## Supplementary Information – Public Information Package Report

### Proposed Maintenance Dredging at the Port of Hay Point

This **'Supplementary Information – Public Information Package Report'** provides NQBP's responses to this additional information request.

**Response to GBRMPA's peer review of the  
dredge plume modelling**

Figure 11: Measured (blue) and modelled (red) near surface currents at Site 1 and measured wind conditions during September 2011 model calibration period.

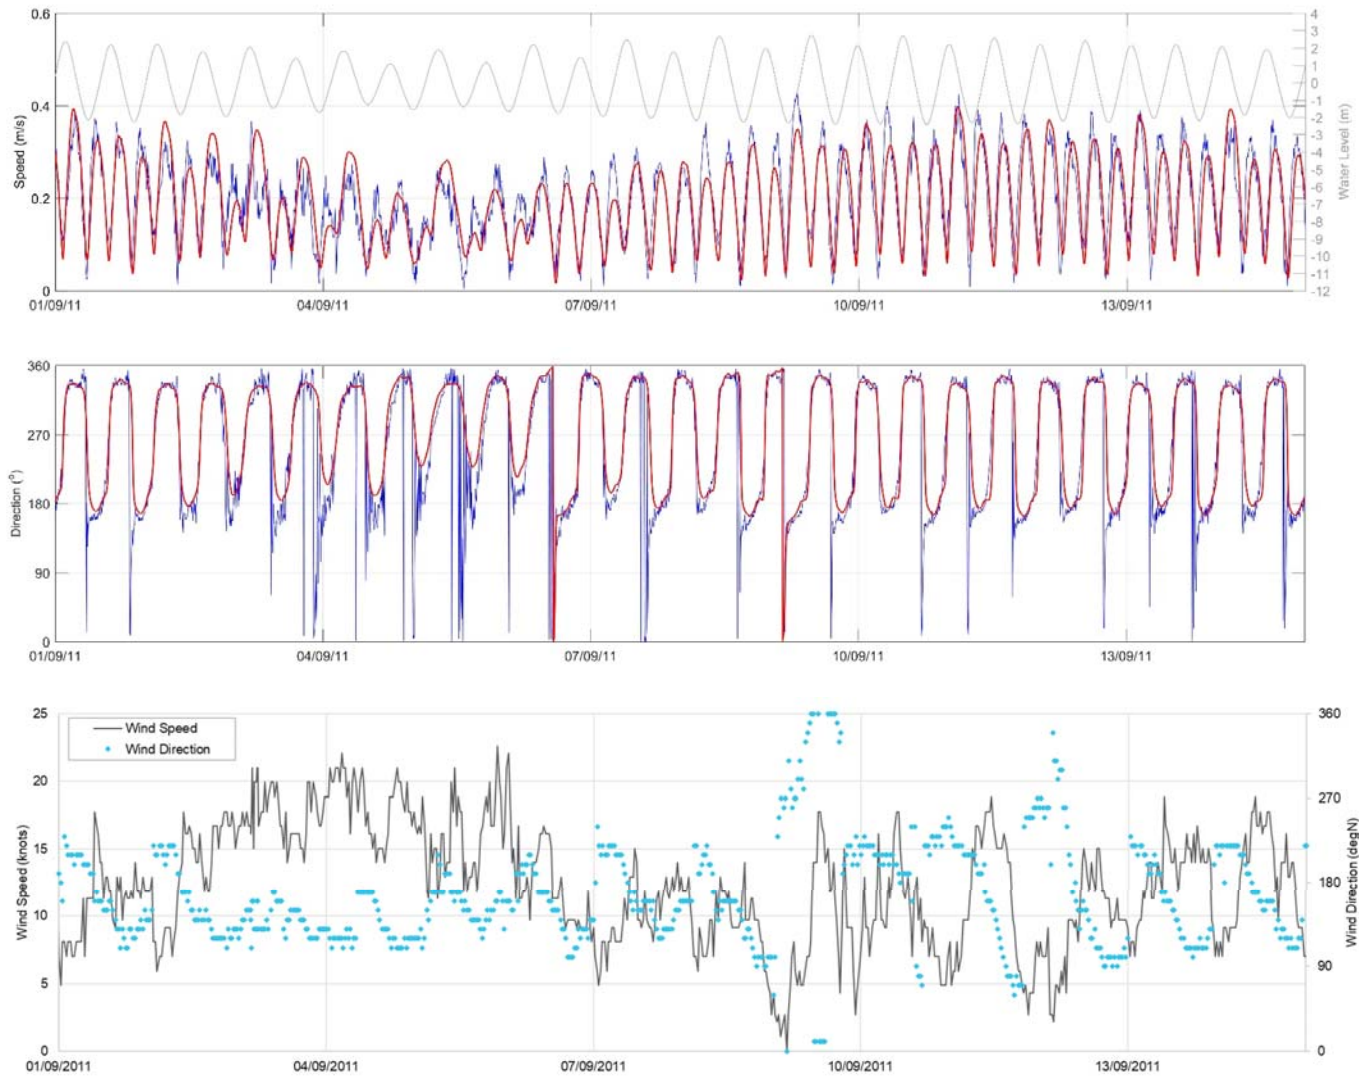
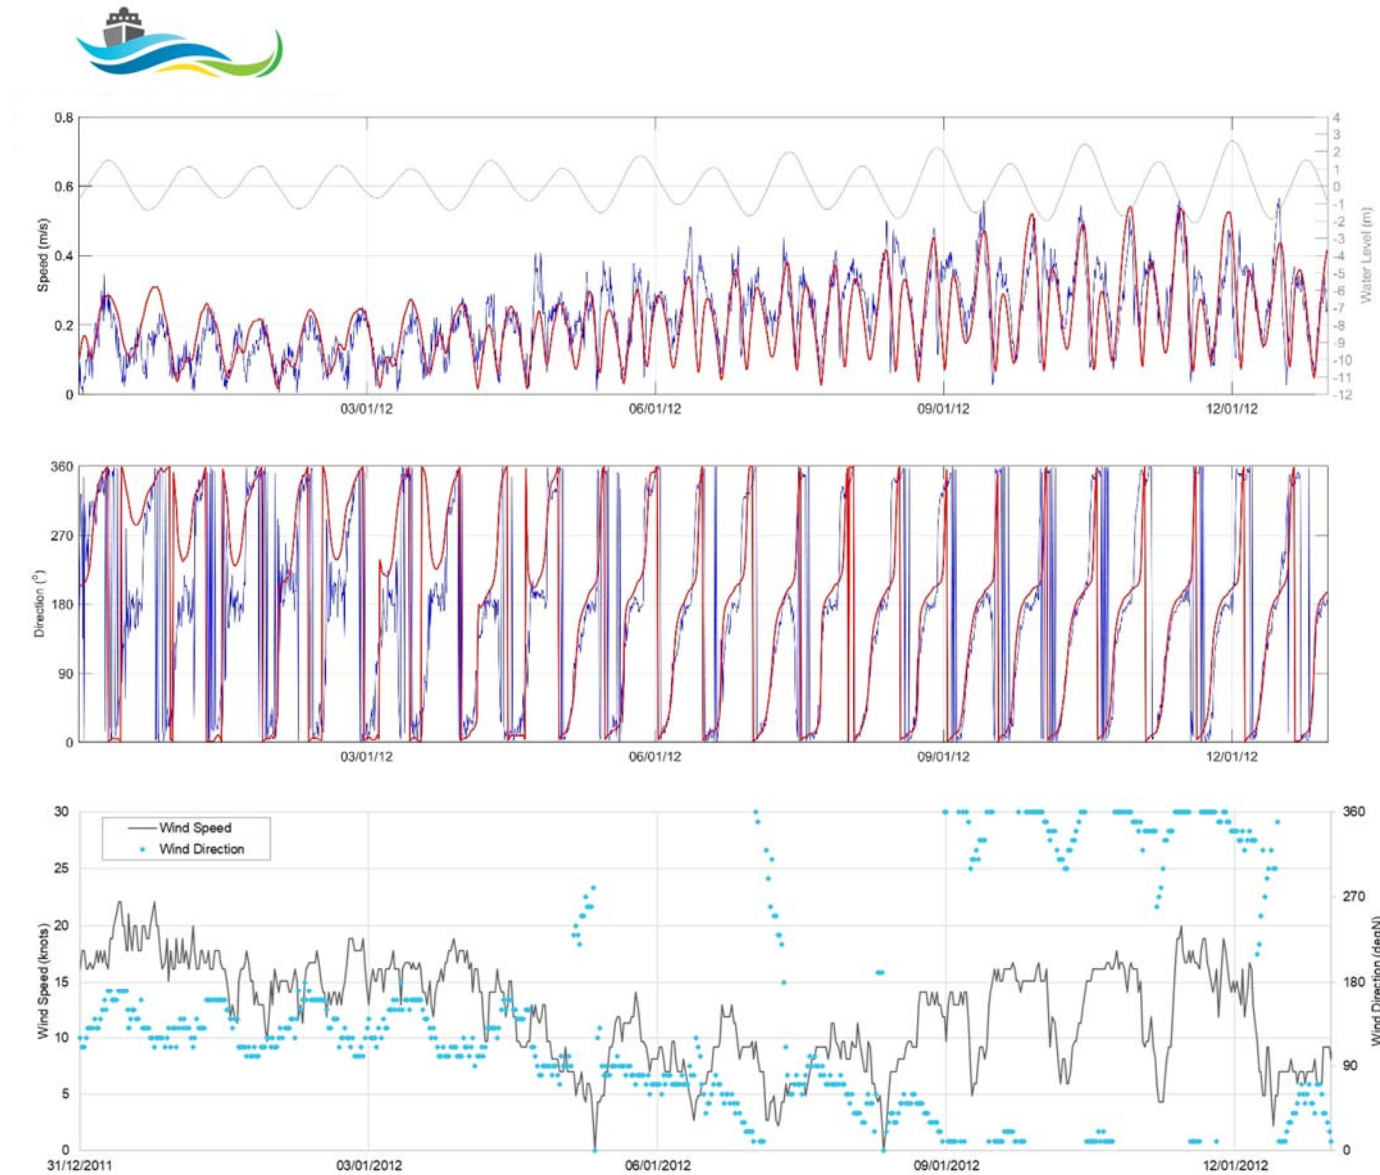
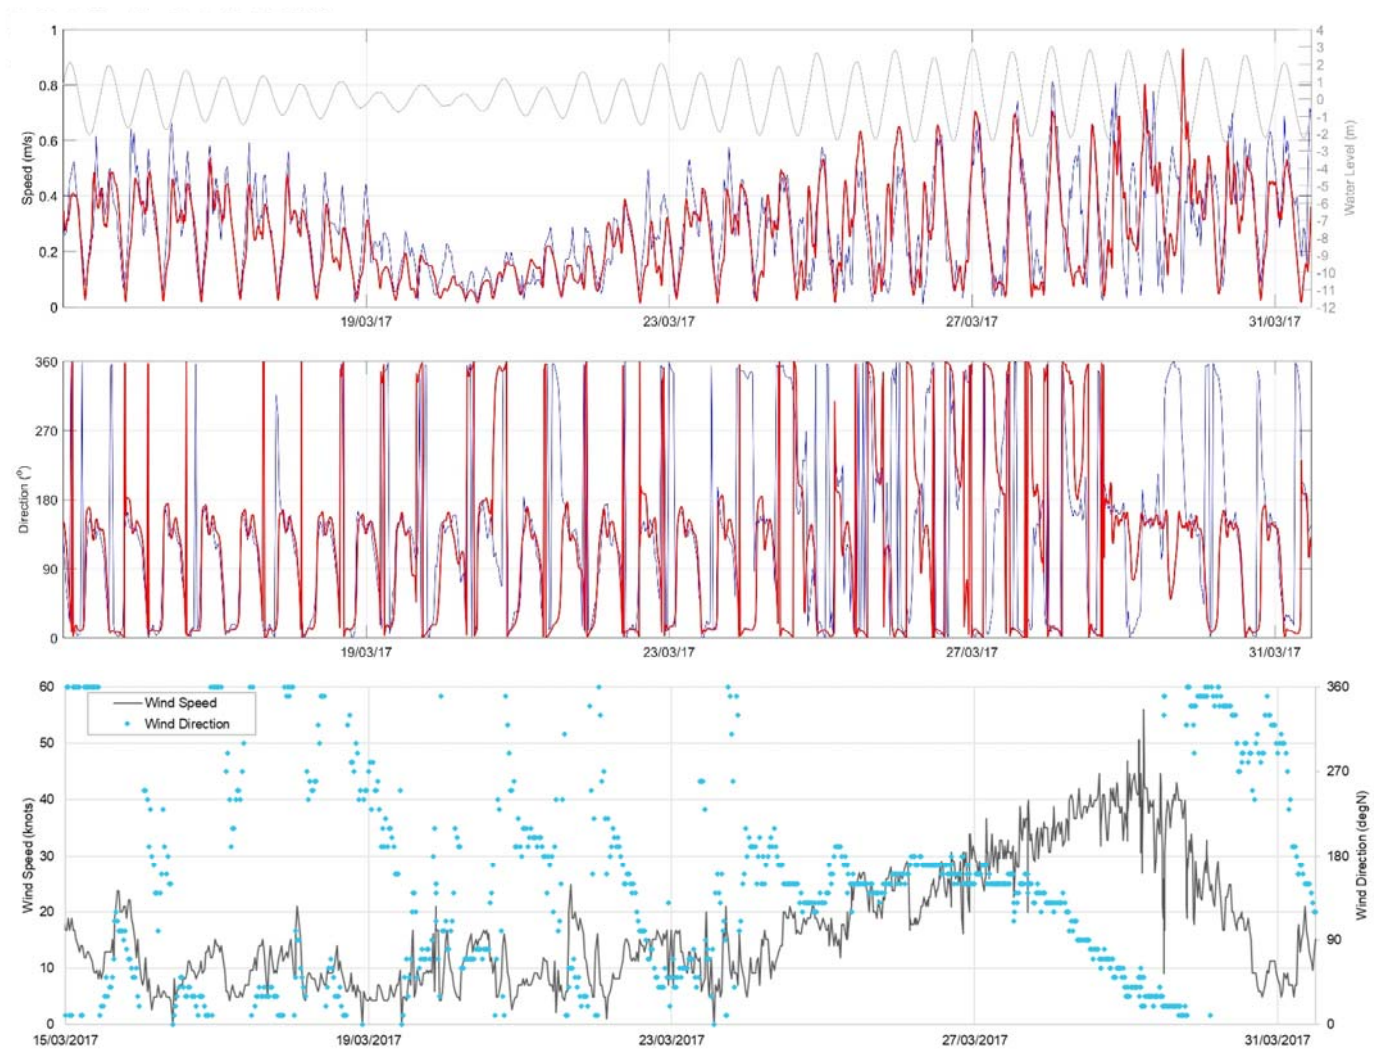
P36 Figs 24-29, 30-31: should also plot the residuals on the same plot scale to more easily identify the timing and amplitudes	
P40: high winds should include strong SE Trades not just TCs	
P36 Figs 32-40: Should show winds to assist with determination if residuals are from them – and again the residual currents – preferably along the tidal principal component directions	
Fig 41-46: Near bed & near surface - what height? Are the top line plots current residuals? Not documented. Would be good to see a few plots showing the vertical profile from both the model and observations on a shorter time frame – e.g. turn of tide	
P59 S4.4.1: Were wave-current interactions included in the final dredge model?	
Under-representing waves probably due to the use of Mackay waverider as forcing – waves would have shoaled at that location so when applied to the southern boundary forcing it is likely to be too weak.

Wind conditions during the three tidal current calibration periods are shown along with the current speed and direction calibration plots in Figure 11 to 13. The plots are for the near-surface current calibration, as opposed to the mid or near-bed, as currents in this layer will be more influenced by wind conditions.
